2020 Fruita Roundabouts Project

ADDENDUM NUMBER 1

This Addendum #1 is hereby issued to correct and supplement the Bid Documents for the 2020 Fruita Roundabouts Project with additions and deletions to the Bid Instructions; virtual Pre-Bid information; answers to questions received to date and structural drawings for the sculptures.

**STRUCTURAL PLAN/
DETAILS**

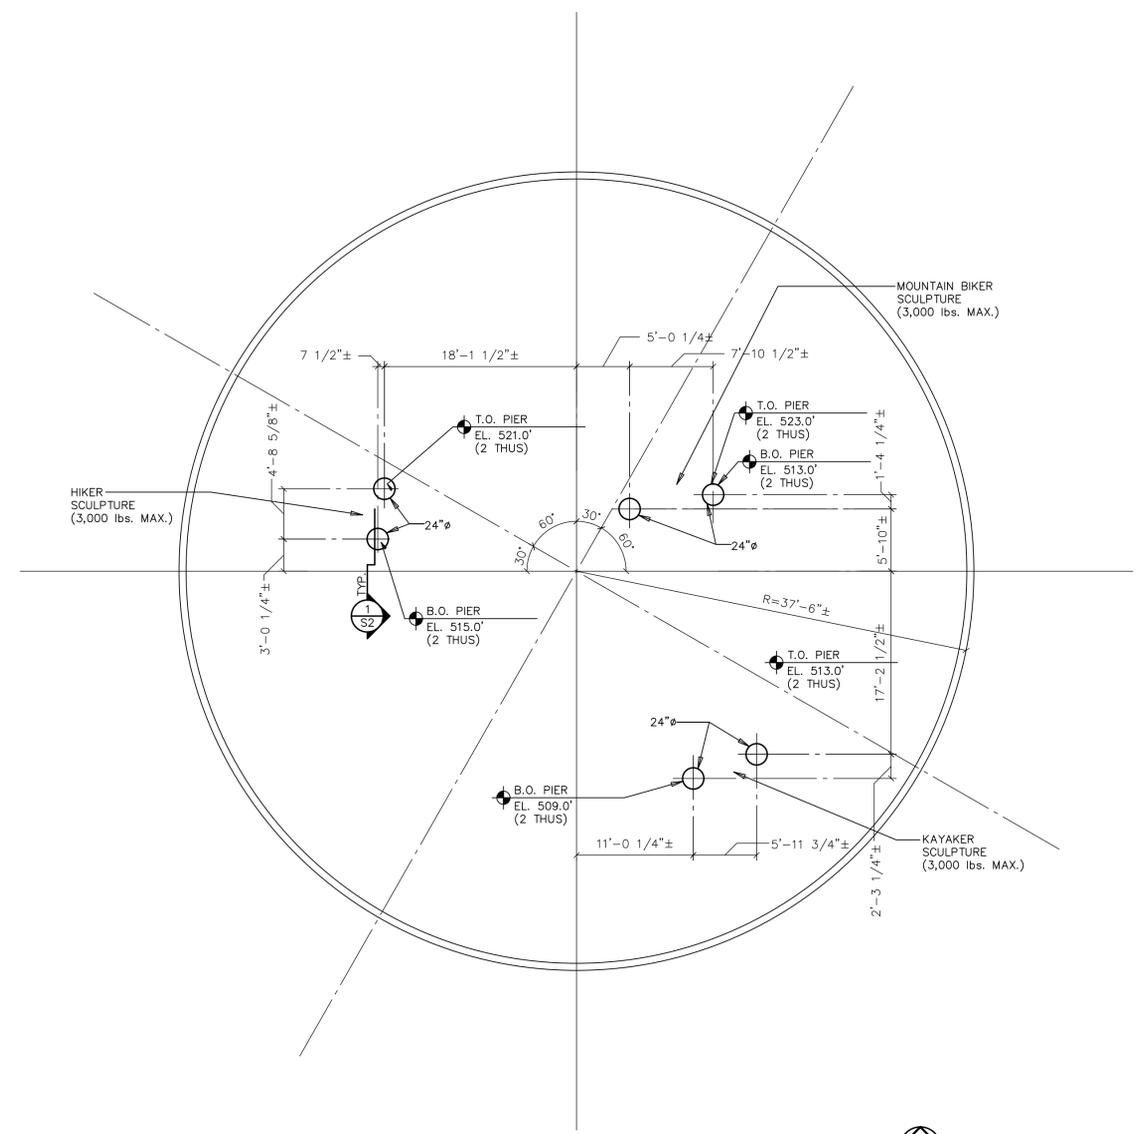
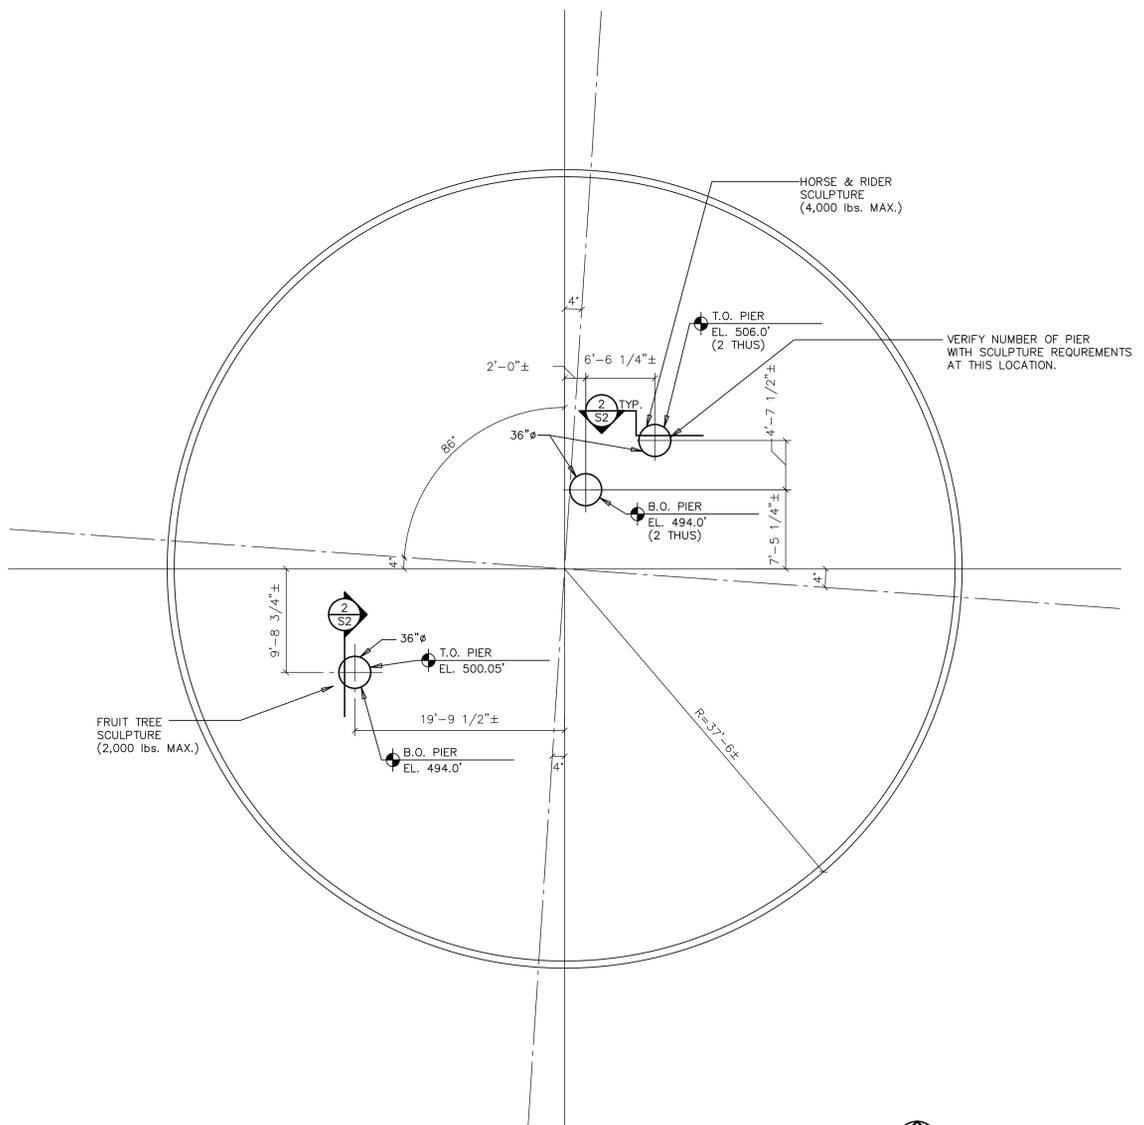
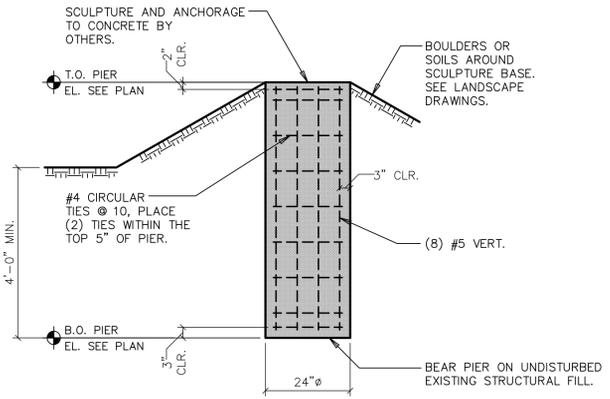
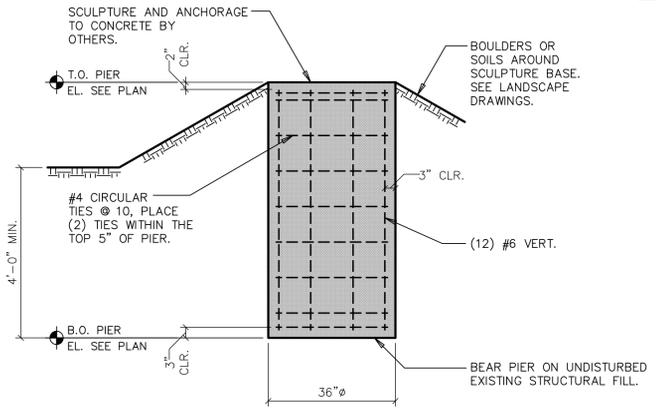
- 4 **Sculpture concrete base size and spec**
 - a. **NVIZ: See Structural drawings for all concrete sculpture bases.**
 - b. **Fruita: The structural drawings are attached to this Addendum #1.**
